J4u03 improvements for 212Gbps (179.9.4.6.2 J4u03 proposed revisions) IEEE P802.3dj Plenary (10-14 Nov 2025) Bangkok

Associated comments (P802.3dj D2.2): 276, 358, 201, 207, 224

Author/Presenter: John Calvin (Keysight Technologies)
Principal contributor: David Gines (Keysight Technologies)

Based on draft release of IEEE P802.3dj™/D2.2

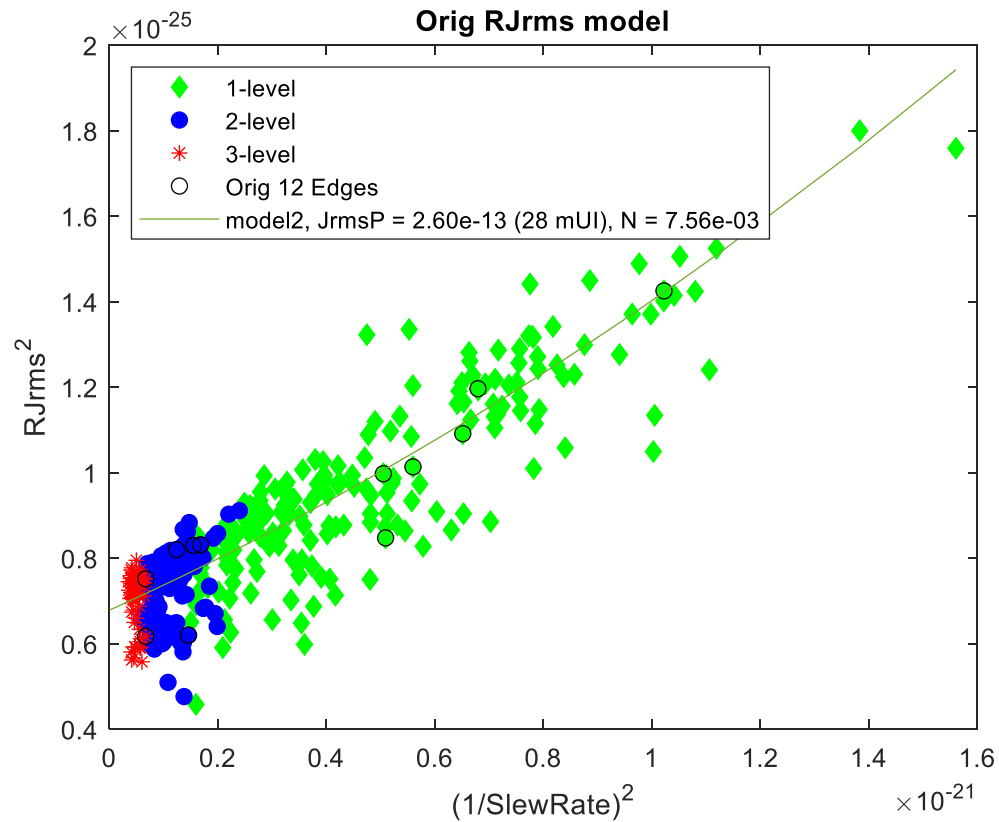
JNU is affected by slew rate

JNU is affected by slew rate and has behavior similar to Jrms. JNU goes up and becomes more variable with increased channel loss. (note the different scales in the two plots)

Model for RJrms

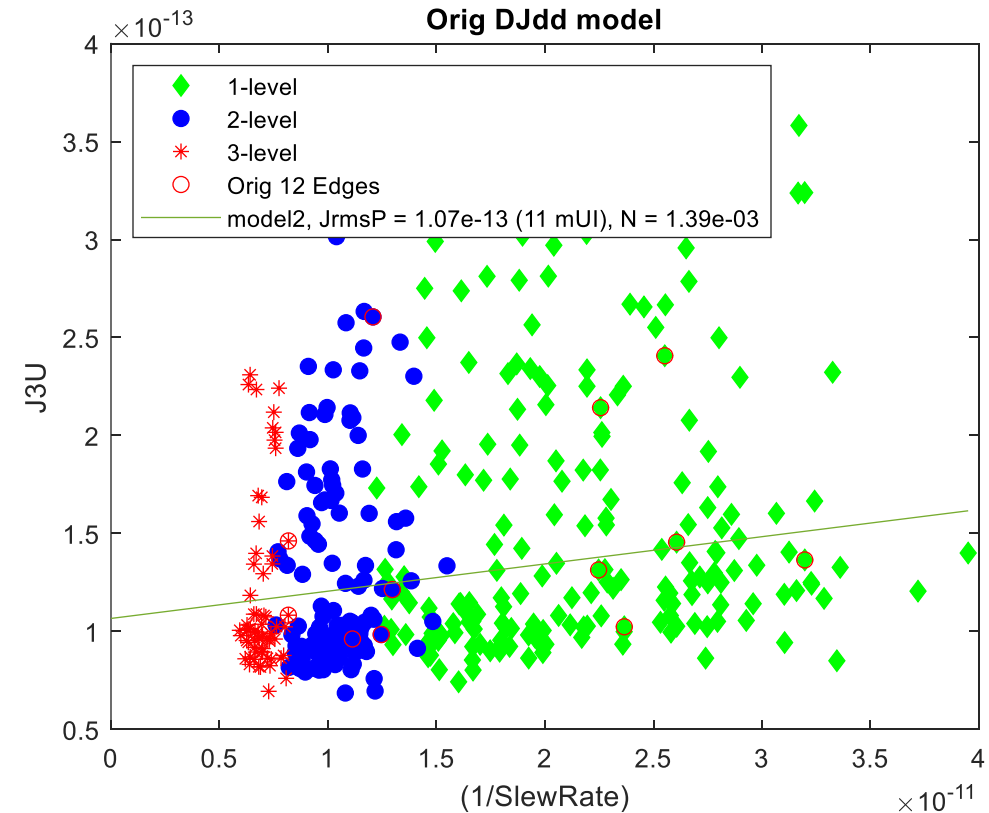
Here is what the models for RJrms and DJdd might look like (after a 31dB Channel)

BERT, 106.25 GBd, PRBS9Q, 50 mUI RJrms, 50 mUI PJpp, Channel 31dB ISI

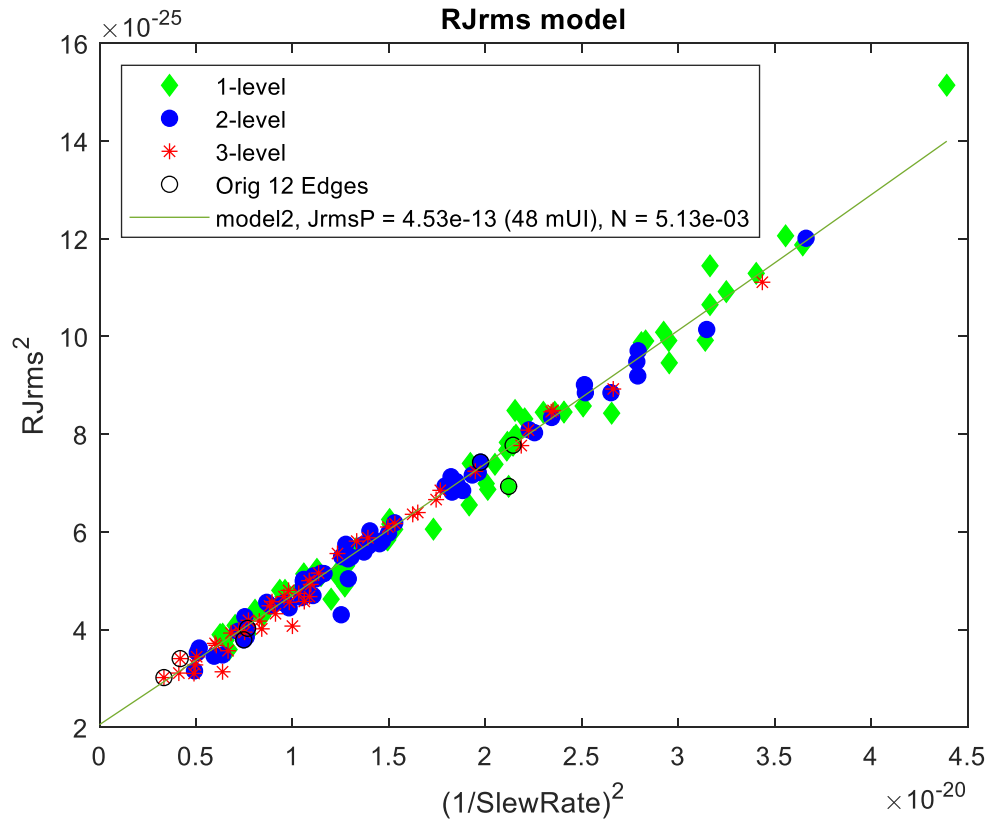
Model for RJrms

Field deployed JH4U beta-tool results.

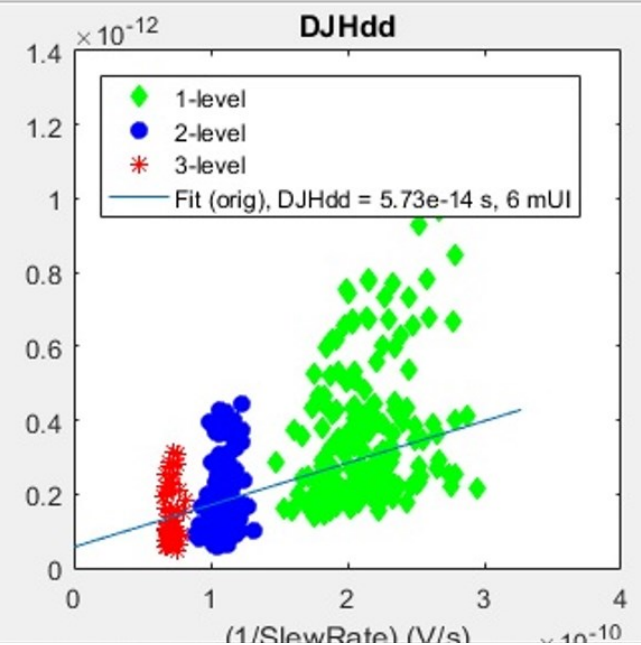
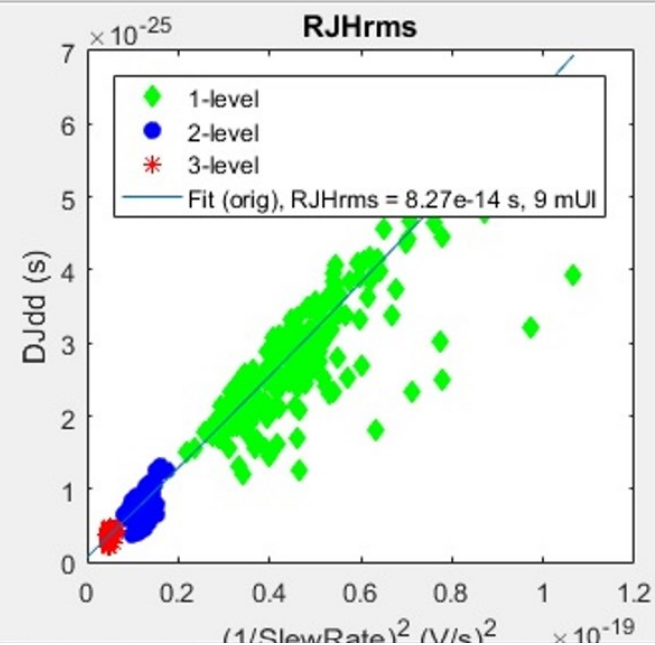
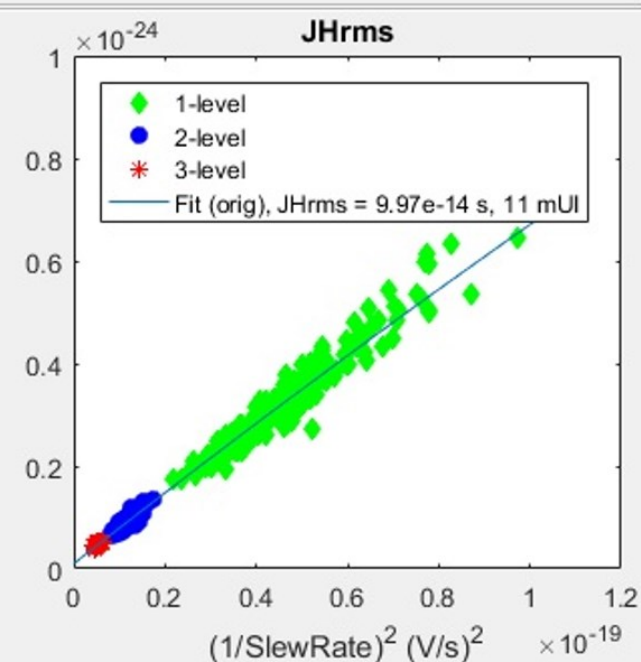
Run		
	seconds	mUI
JHrms	9.9698e-14	11
RJHrms	8.2740e-14	9
DJHdd	5.7341e-14	6
JH3U	6.0186e-13	64
JH4U	7.0116e-13	74
